SUBJECT: PLANS AND PROPOSAL ADDENDUMS

PROJECT: F 2B23(047)

CONTROL: 0045-19-065

PROPOSAL ADDENDUMS

US 82
TYPICAL SECTIONS

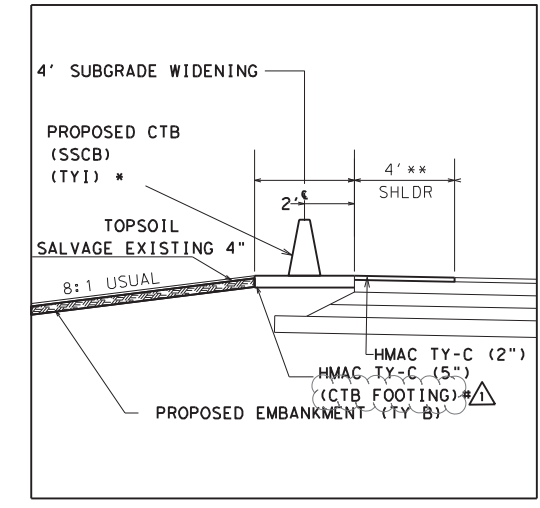
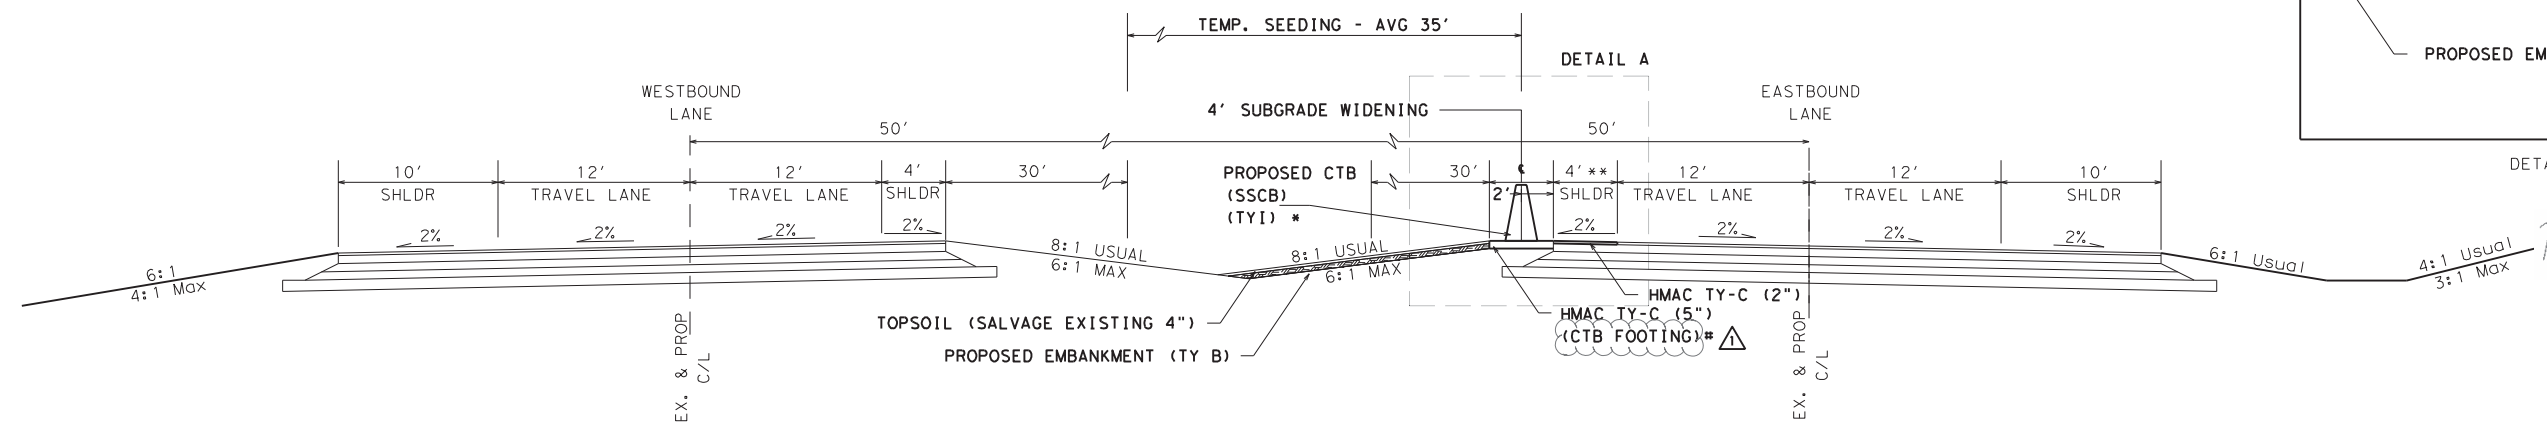
SHEET 004: REVISED TO ADD CTB FOOTING NOTES

1 REVISE SHEET, ADDENDUM #1 - JULY 17, 2023

CTB FOOTING IS INCLUDED IN PAY ITEM 514. SEE APPLICABLE SPECIFICATION
